2019 Project Review Sheet (2020 Construction)

Project #	Project # 19-231	
Project Title:	Add crosswalk	
	Neighborhood: Ballard, 98107	
Location:	Area: North side of the intersection at 14th Ave NW and NW 56th St	
	SDOT Contact Information	
SDOT Reviewer Name:	Carter Danne	
Reviewer Phone Number:	(206) 684-0817	
Review Date:	August 9 th , 2019	
	SDOT Project Summary	
SDOT approves project Yes		
oxtimes Yes, with revisions $oxtimes$ No	;	
adding a refuge area, adding	o volumes do not warrant a marked crosswalk, SDOT recommends g an ADA compliant curb ramp, and formalizing the restricted ch of the intersection to improve pedestrian visibility.	
⊠ Yes	artner with another program:	
☐ No Partnering Program: Traffic S	Spot Improvements

YVYC 2019: Project 19-231, North side of the intersection at 14th Ave NW and NW 56th St

Image:

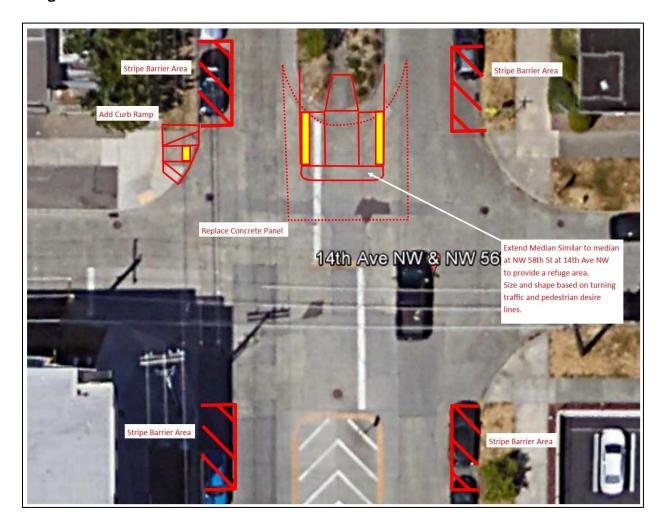
- Extend the median south for pedestrian refuge
- Add striped barriers to narrow the travel width of the lanes on 14th Ave NW and to provide a buffer for pedestrians crossing
- Add a new curb ramp at the northwest corner to facilitate east/west pedestrian travel
- Replace a broken concrete panel in the pedestrian path
